DIXIE-NARCO, INC. SERVICE BULLETIN #106

January 30, 1970 Supercedes Service Bulletin #99

MODEL NUMBERS: Brookwood III and Brookwood IV

SUBJECT: Drain Tray Kit

= NEW DRIP TRAY AND SUPPORTS =

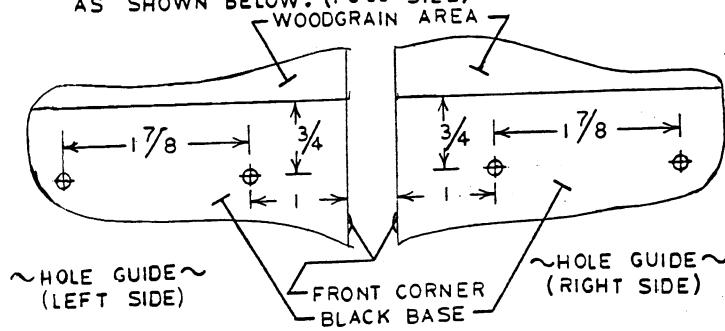
REASON: To provide a means for simple installation and removal of the drain tray for purposes of cleaning.

To convert Brookwood with <u>Metal Drain Tray</u> or Brookwood with <u>Plastic</u>

<u>Drain Tray</u> but without the "Lift Out" removable feature the following parts

are provided:

NOTE: Lock strip is no longer needed, discard it.

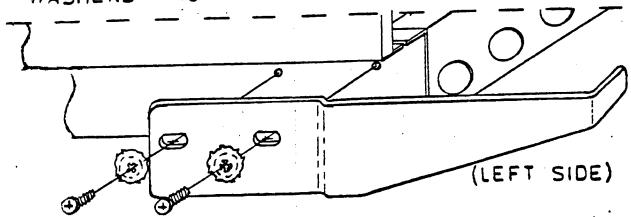
DRILL TWO 1/8" HOLES IN EACH SIDE OF BOTTOM AS SHOWN BELOW: (FULL SIZE)

2) MOUNT TRAY SUPPORTS WITH SCREWS AND WASHERS PROVIDED AS SHOWN BELOW:

- 3) ATTACH DRAIN TUBE TO NEW DRIP TRAY
- 4) INSERT DRIP TRAY ON SUPPORTS
- 5) INSERT CUP GRID IN DRAIN TRAY
- 6) IT MAY BE NECESSARY TO ENLARGE HOLE IN CABNET BASE TO FREELY ACCEPT DRAIN - TUBE
